Technical Service Information

FORD AODE/4R70W NEW DESIGN INTERMEDIATE ROLLER CLUTCH

NEW DESIGN INTERMEDIATE ROLLER CLUTCH

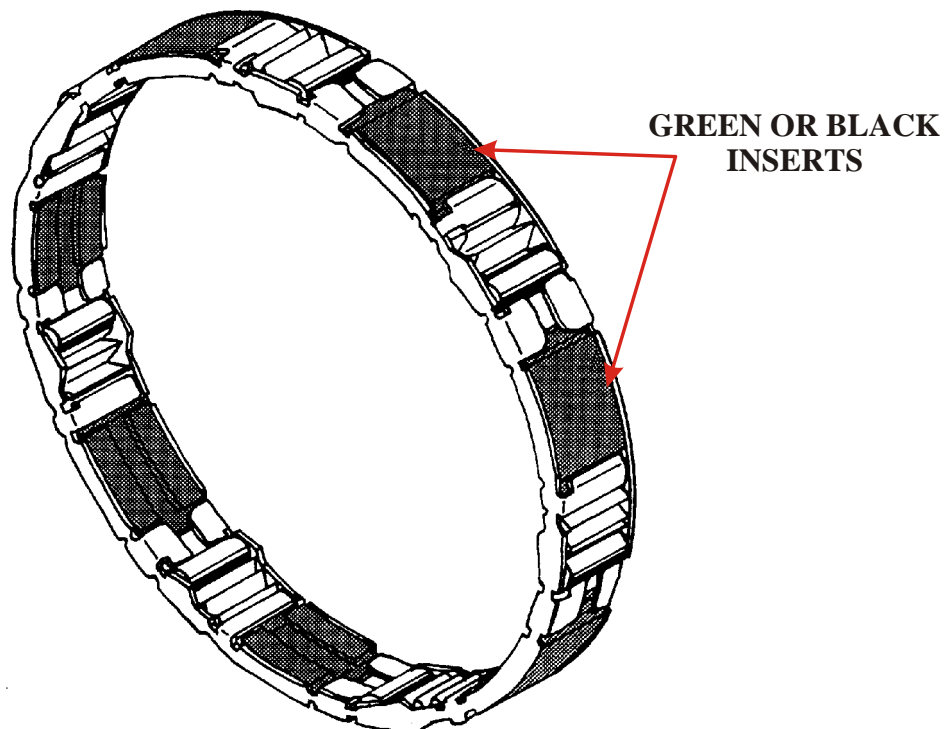
There is now available from Ford Motor Co., a new design Intermediate Roller Clutch Assembly for the Ford AOD-E transmission. The new design roller clutch has stronger springs, and is identified by Green or Black plastic inserts as shown in Figure 1. The previous design level roller clutch has White plastic inserts.

The new design level Intermediate Roller Clutch Assembly will retro-fit back to 1992 model Ford AOD-E transmissions, and is available under OEM part number F4AZ-7AO89-A.
